LIGO-T040096-01-R

Upper-Intermediate Mass for ETM Controls Prototype Quad Pendulum  
Suspension

**Product Design Specification**

### QUESTIONS FOR DESIGN MEETING 013, MONDAY JUNE 28<sup>TH</sup> 2004

**1) Reduce the 'n1' (half separation of the break-offs in y-dir) from 70mm to 50mm:**

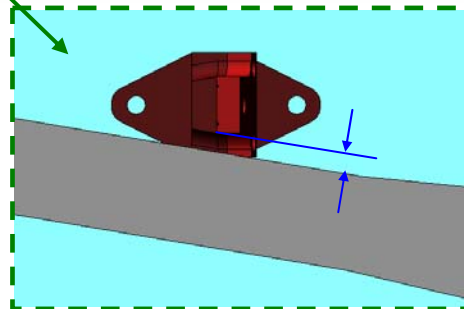
- i. Can this be done without affecting the suspension performance?

>>>> I need to know whether it would be possible to reduce the n1 value  
>>>> on the Quad to 50mm from 70mm. The problem is that with the current  
>>>> layout the blade will interfere with the clamp. Calum thought that  
>>>> reducing n1 to 50mm shouldn't affect suspension performance greatly  
>>>> considering that the n0 is 200mm.

>>> Changing n1 to 0.05 and also l1 to 0.313 ( from 0.304 ) to keep  
>>> overall length of quad the same does have a slight adverse affect on  
>>> the yaw. The frequencies are Ok but coupling to the highest mode

>>> (at around 3.1 Hz) gets worse - typically the Q doubles. Although  
>>> this isnt directly affecting the settling time, which is dominated  
>>> by the lowest mode, I am musing about whether there could be any  
>>> problems (for example applying Ken's latest ideas about damping as  
>>> combination of active for the low freqs and ECD for the higher  
>>> ones). I want to muse a bit longer. Will get back to you soon.

>> I wanted to ask if making n1 0.06 is enough of a change to fit in  
>> wire clamps - it gives a less significant change to the yaw  
>> behaviour. I am still musing on whether the 0.05 is acceptable but  
>> thought i would ask anyway.

> As we are looking at altering the blade to having a narrower tip it is  
> not necessary to move the break-off as far from the 0.07m as I  
> proposed. I have checked the model - moving the wire clamp to 0.06  
> from the centre of mass - and this seems to be okay.

That's good! Let's settle for n1 = 0.06. I'll check what l1 has to be to  
keep overall length same.

It is best that a combination of solutions proposed in 1 and 3 are adopted for the design.

- Use a narrow blade design with #8-32 holes along the length of the blade.
- Reduce n1 to 60mm.

2) Angle blades further. Diagram shows increase from 9.5degrees to 12degrees:

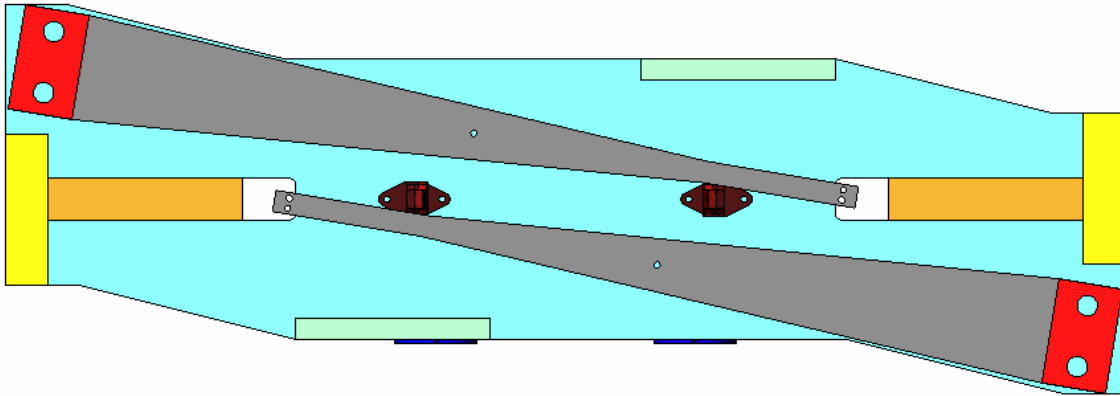
- i. Off-axis Moments (Lxy, Lyx, highlighted in **RED**) increase such that they are higher than Moments in the Y plane (Lyy).
- ii. Norna – I expect that this is not good?!

### 3) Reduce blade width at tip to 10mm:

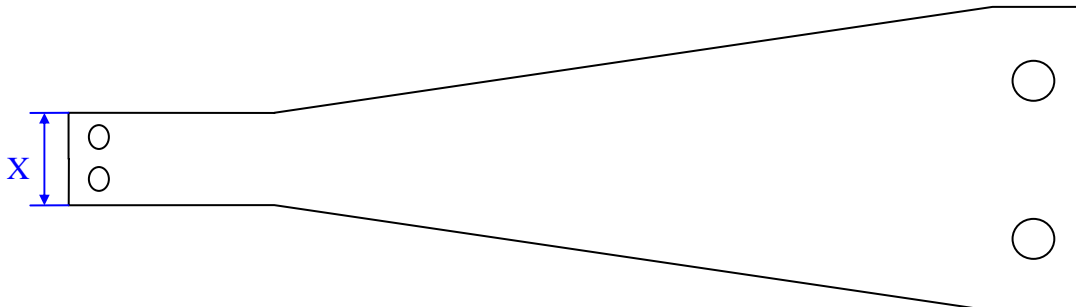
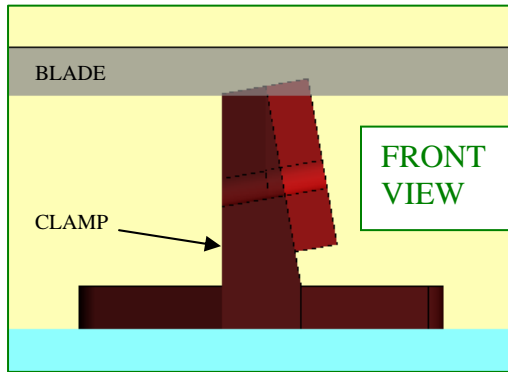
```
>>>Would it be okay to move to a 10mm width at the thin end instead of
>>>15mm?
```

```
>>>I know that in the past that you generally preferred not going below
>>>12mm however I imagine this may have been in the situation where
>>>there was a neck?!
```

```
>>To answer your question about the blades. It sounds like the design
>>you are proposing has a trapezoidal shape. Is this correct? I suppose
>>the issue then is how much material there is around the holes drilled
>>for the clamp. If the holes are one behind the other then 10 mm width
>>is probably OK. Of course the spring constant of the blade will be
>>slightly
>> different with this revised shape but it is hard to say how much it
```

OK, I now understand the shape that you described. It looks reasonable assuming that:

1. The bolts are strong enough for the loads involved
2. The bolt heads do not interfere. (I would think that the holes must be drilled fairly close to the edge for this not to be a problem, unless you envisage a special clamp design).

- i. Is this going to affect the blade performance? Shouldn't be a problem – Comments from DM013.
- ii. Can we use #4-40 bolts for the blade wire clamp? Probably be okay (original BWC concepts has #2-56 but deemed fiddly to work with) but maybe we could use #8-32 but position the holes along the blade.

**4) Raise Blades to Avoid Interference:**

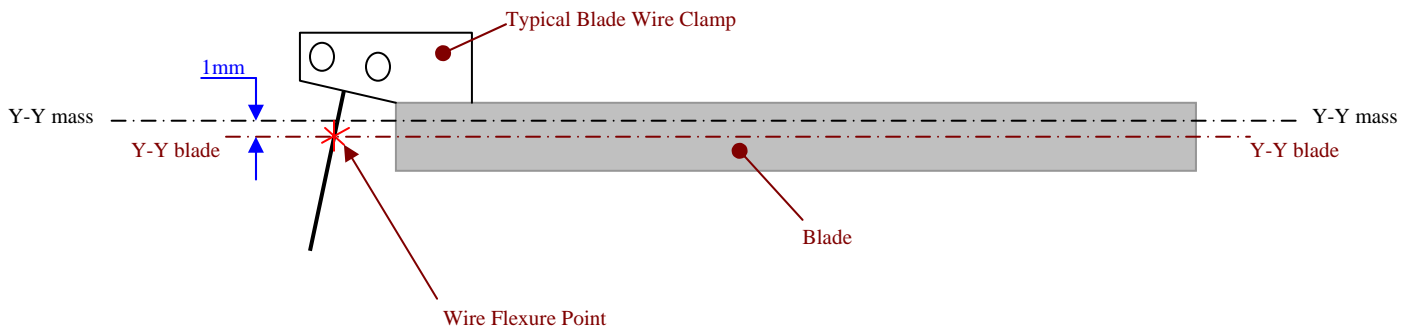
The blade collides with the clamp in the Y-Z plane by around 1.5mm. Could we raise the height of the blade to avoid this interference (adjusting for the break-off height via the blade wire clamp)?

- i. As the blade is not guaranteed to be perfectly flat under load, there is still a possibility that the blade will hit the clamp when loaded.
- ii. Moving the blade from the default position, and compensating with the clamp, will cause a cross coupling which will in-turn affect the suspension performance.
